BCA ASSESSMENT REPORT

**Aspect Industrial Estate
Lots 54-58 Mamre Road, Kemps Creek
Warehouse 9 (Lot 9)**

**Prepared For:
Mirvac**

Revision 3

Figure 1 – Warehouse 9 Perimeter Vehicular Access per BCA C2.4.

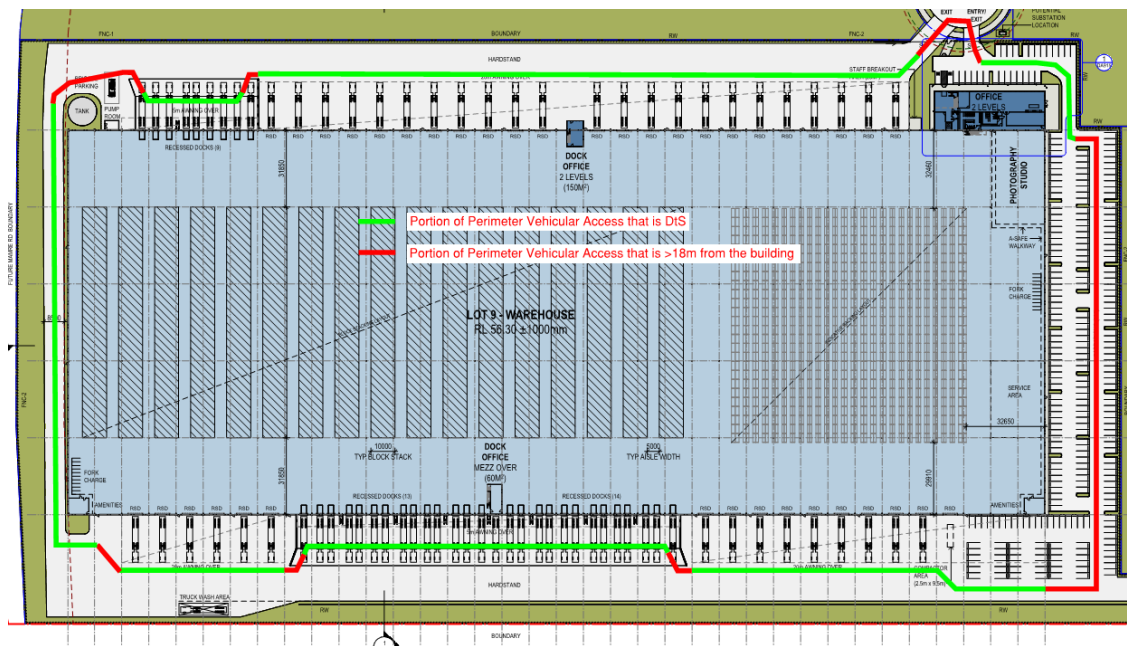
Comments: The proposed building does not comply with the provisions of C2.4 and thus the following non-compliance issues are required to be addressed as a Performance Solution by the Fire Engineer to demonstrate compliance with Performance Requirement CP9:

- + Perimeter Vehicular Access is greater than 18m from various parts of the building identified in red below.

Note 1: Any proposed gates are to achieve no less than 6m unobstructed width or the reduced width will need to be included in the above Performance Solution.

Note 2: The driveways providing vehicular perimeter access must be designed with adequate loading capacities to withstand a fire truck and the gradients of any ramps and swept paths should take into consideration the requirements of the FRNSW Fire Safety Guideline – Access for Fire Brigade Vehicles and Firefighters. Particular attention is drawn to the 90° turn that is required in the NE corner of the carpark.
